UNITED STATES
DEPARTMENT OF THE INTERIOR
BUREAU OF LAND MANAGEMENTCarlsbad Field Office
FORM APPROVED
BLM NO. 1004-0137
Expires: January 31, 2018**SUNDRY NOTICES AND REPORTS ON WELLS**
*Do not use this form for proposals to drill or to re-enter an abandoned well. Use form 3160-3 (APD) for such proposals.*Lease Serial No.
NMNM125057

EAST BLINEBRY DRINKARD UNIT 13

Apache proposes the attached conformance procedure and WBD's to workover this injection well. (EBDU Waterflood Project Case 13503 R-12394)

**Apache Corporation
East Blinebry Drinkard unit 13
API 3002506476
May 22, 2018**

Proposed

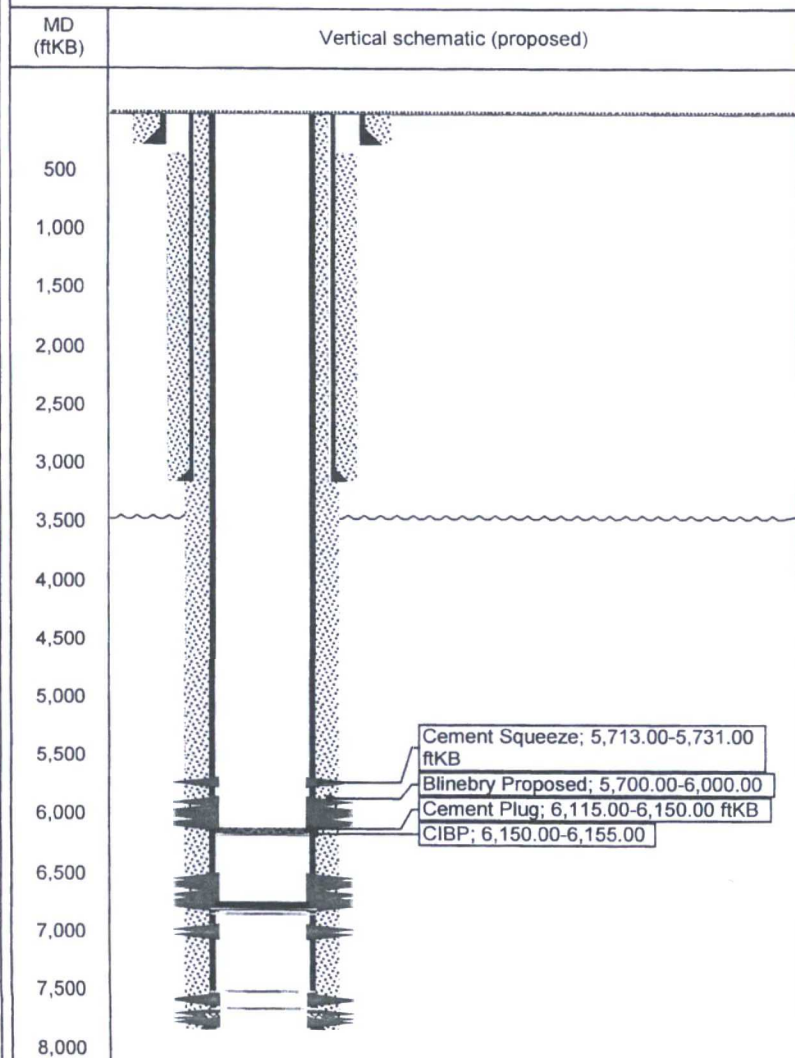
3. TIH with CIBP and work string. Set CIBP at ~6,150' and cap with ^{35' of} ~~2 sacks~~ of Class "C" cement. *or 25 Sacks*
4. TOH with work string. TIH with CIBP and work string. Set CIBP at ~5,760'.
